THE OFFSHORE OIL AND GAS EXPLORATION, PRODUCTION, UNLOADING AND STORAGE (ENVIRONMENTAL IMPACT ASSESSMENT) REGULATIONS 2020

**Applicant provision of Further Information in response to
Notice under Regulation 12(1) sent to LB CCS Limited on
1st July 2024.**

Figure 105-1 Offshore Power Cable No.1 -PoA to Douglas CCS Alignment Sheet KP 0+000-KP5+000 (Document reference 1025H0BSDG84110)

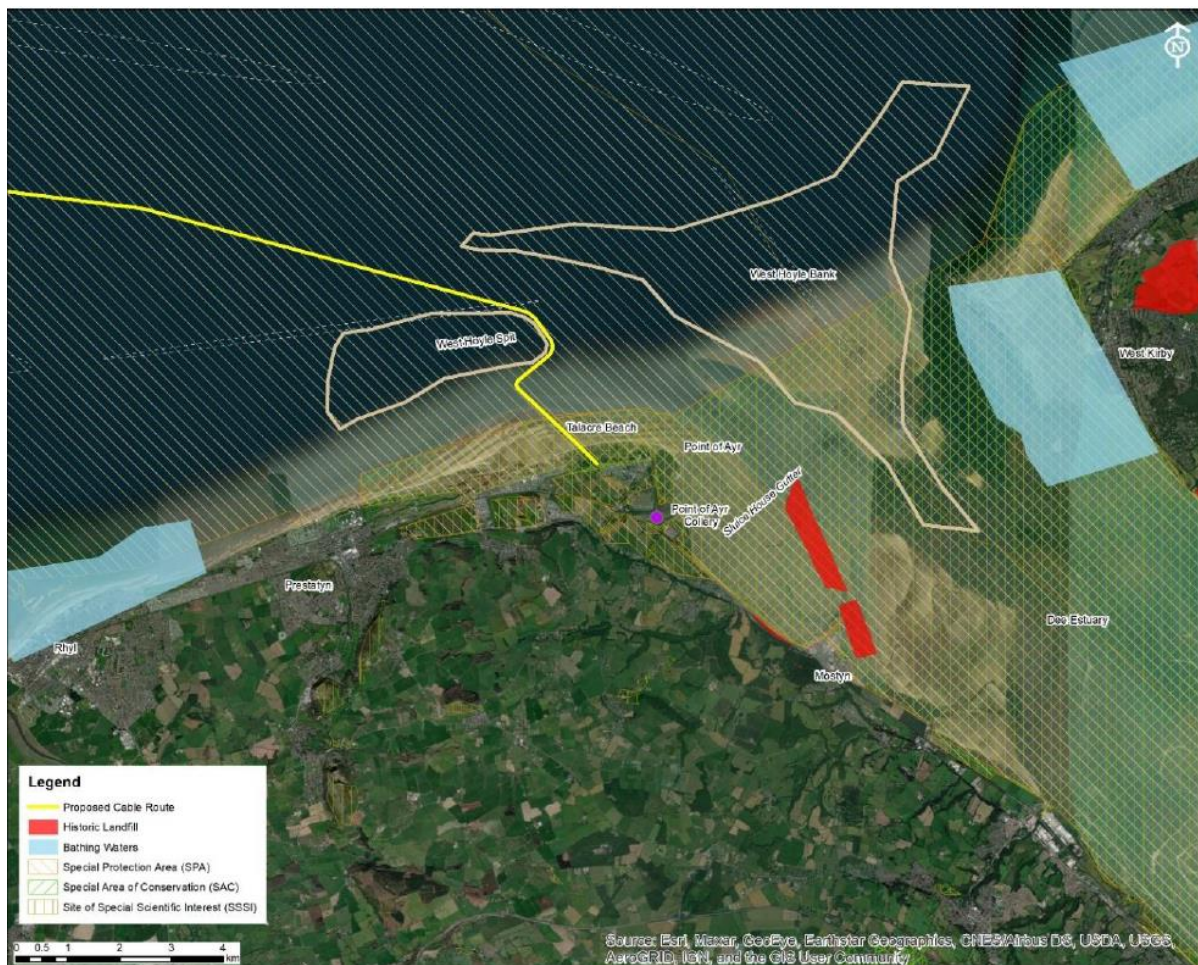
The conclusion that there is no adverse effect on the integrity of the Dee Estuary SAC as a result of activities associated with the Proposed Development on page 67 is queried. Please provide additional information/evidence and clarity on how the assessment was derived in the absence of applicable sediment contamination data for the intertidal zone area and areas of sand wave clearance within the vicinity of the SAC.

Eni Response: Seabed disturbances due to construction and decommissioning activities could potentially lead to the remobilisation of previously sediment bound contaminants which could impact the surrounding benthic communities in the SAC. However, the assessment in the EIA, based on the site specific physical processes modelling, suggested that the nature of the construction activities is not likely to result in any remobilisation of previously sediment bound contaminants due to the already turbid and dynamic nature of the intertidal zone. This formed the basis for the conclusion presented in Table 1.10 of the RIAA for the Dee Estuary SAC.

The Applicant evaluated the sediment contamination data for the intertidal zone area and areas of sand wave clearance within the vicinity of the SAC based on the activities that will be undertaken in the area and can have a potential release of contaminated sediments resulting from the cable installation operation in the intertidal zone during construction; and a potential for release of contaminants through the HDD drilling process during construction (**Figure 105-1**)
